Modification Application to DA 10.2014.743.3

Submitted under Section 4.55(2) of the EP&A Act, 1979

Approved staged residential development at No.2 Kulgun Court & Nos.41-43 Matong Drive, Ocean Shores

June 2021

Fig 3. Proposed staging diagram (refer also to full set in the attached **separate annexures**).

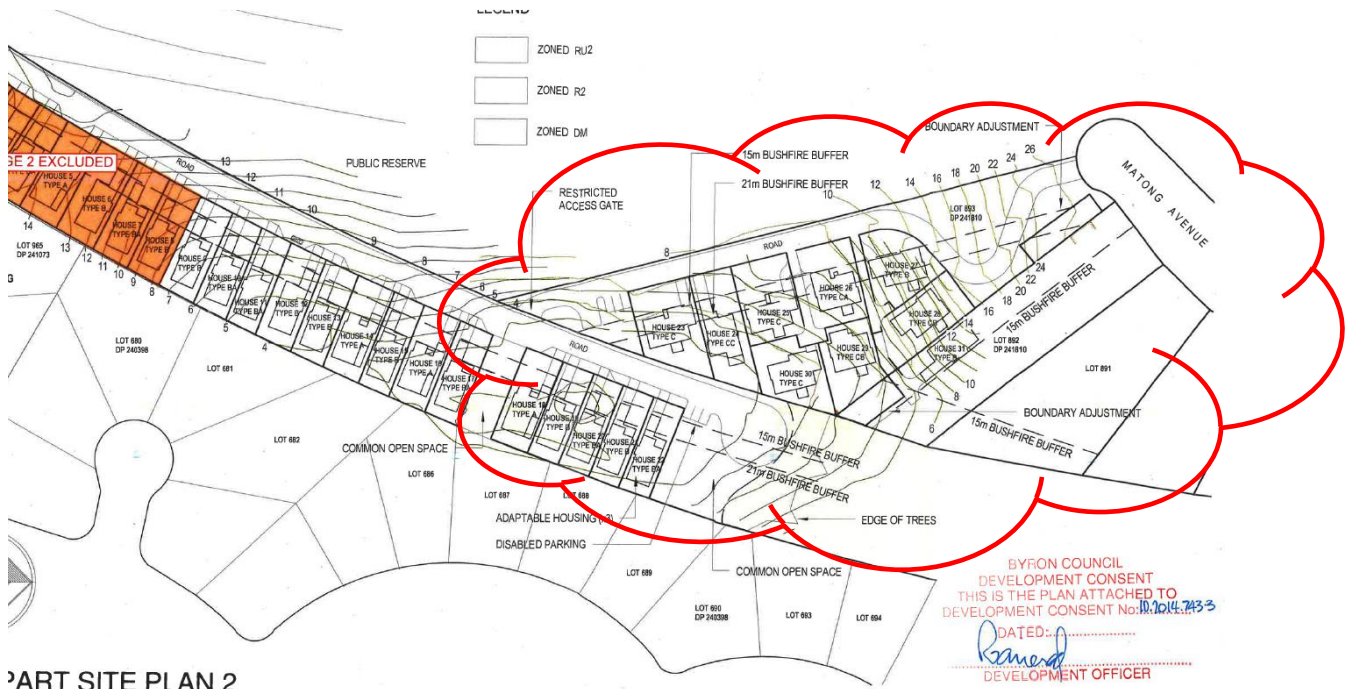
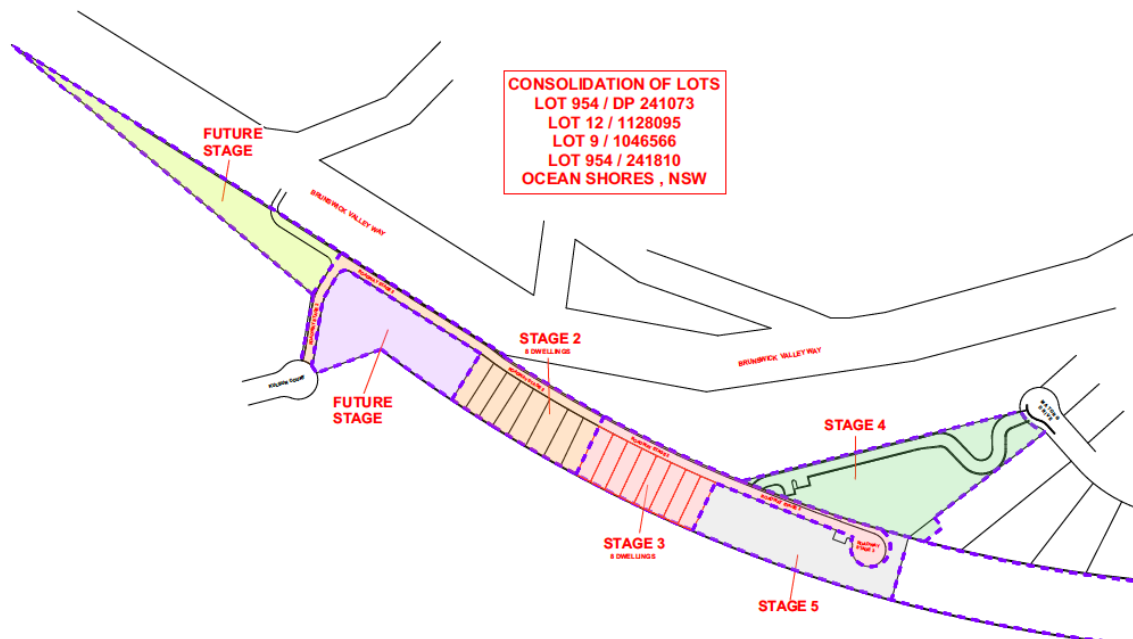
MODIFICATION No.1 – Modification of the Proposal Description as it relates to staging:-

Delete the following existing description of staging:

And replace it with the following staging description: -

Stage 3 – Eight Dwellings and extension of internal road works as shown. Associated strata subdivision and driveway, car parking, and access works to the lot fronting Matong Drive (stage 4) inc. a locked gate for Emergency Services (gate to be locked to prevent access through the site to Kulgun Court/Brunswick Valley Way), Services and Easements as required;

Stage 4 - Works located on land fronting Matong Drive, dwelling construction and access, services, easements and strata registration as required;

Stage 5 – Site works and construction of six (6) dwellings, services, driveway, carparking, easements and Strata Subdivision.

Fig 4. Proposed modified site layout (refer also to full set in the attached **separate annexures**).

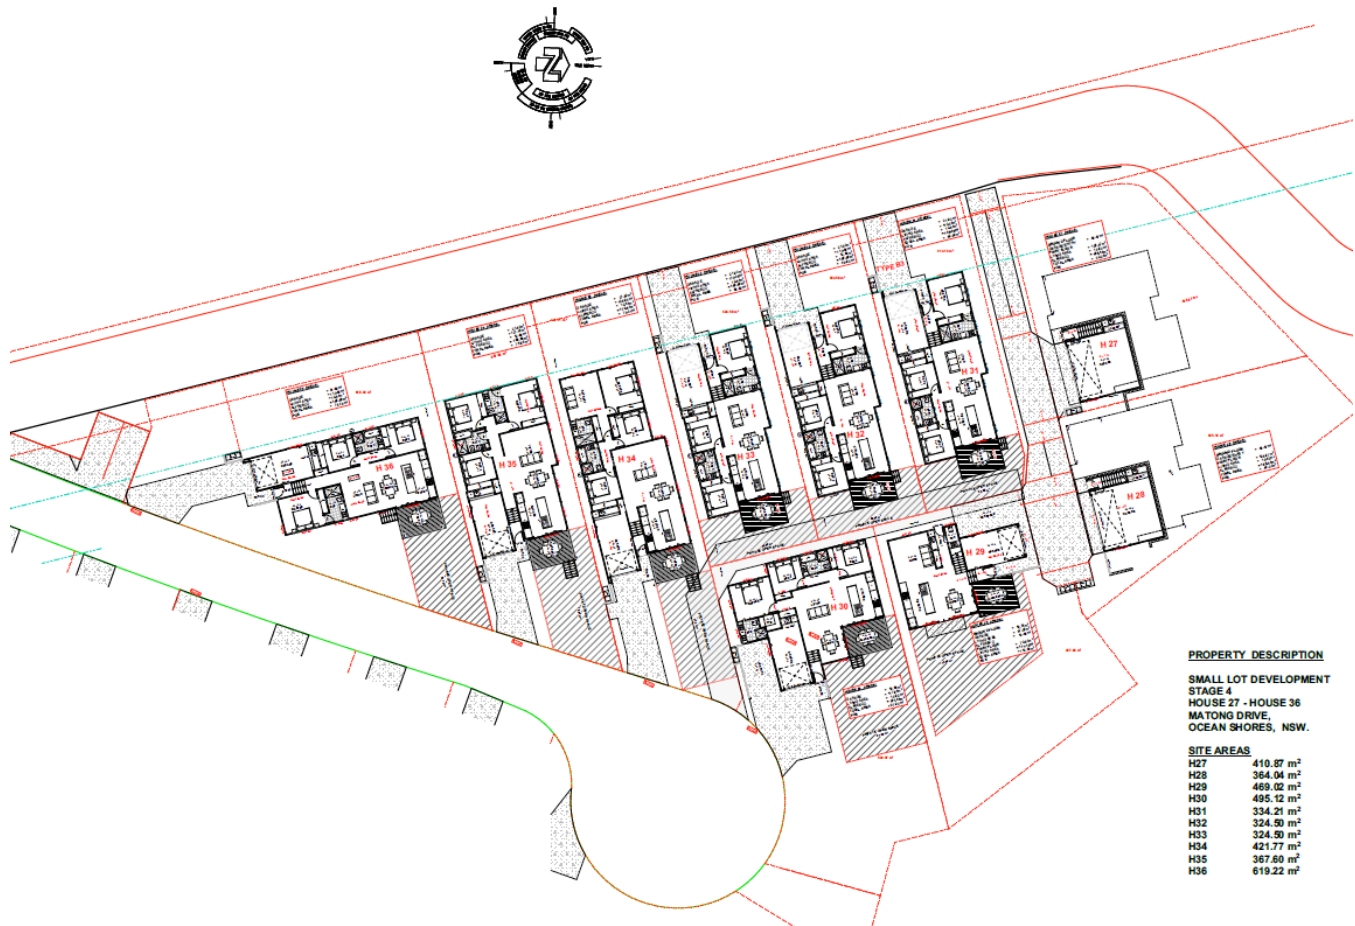
In summary, the proposed amendment seeks increase the number of dwellings in the above stated area from eight (8) to ten (10) by way of adopting a revised design approach to the dwellings proposed, which not only increases the yield in this particular area, but also incorporates a revised internal driveway configuration. This design change has been bought about by way of adapting to commercial needs and wants of the housing market and through the design evolution process highlighting the ability to amend the access arrangement in a more efficient manner.

- a. Addition of two new dwellings.
- b. Provision of access to each dwelling internally (from either Kulgun Ct or Matong Drive), with the likely exception of houses 26, 27, 31-33, which will likely use the Matong dve access predominantly.
- c. Adoption of a design philosophy more closely aligned to a modern aesthetic.
- d. Retention of three bedrooms in each dwelling.
- e. Adherence to previously approved / agreed, bushfire management measures; and
- f. Integration of additional site topography data and therefore the amended plans show a more accurate representation of existing levels and proposed sub structure treatments.

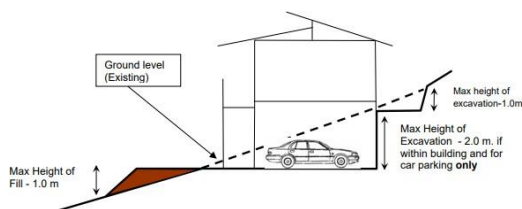
Complies – Whilst the site is challenging, given existing topography, the proposal complies, with all houses demonstrating compliance inclusive of houses 27 and 28 only exceeding the 1m restriction due to self-supportive retaining to provide car parking. In this regard excavation and filling is required to ensure compliant site access and suitable building pads for the buildings are provided.
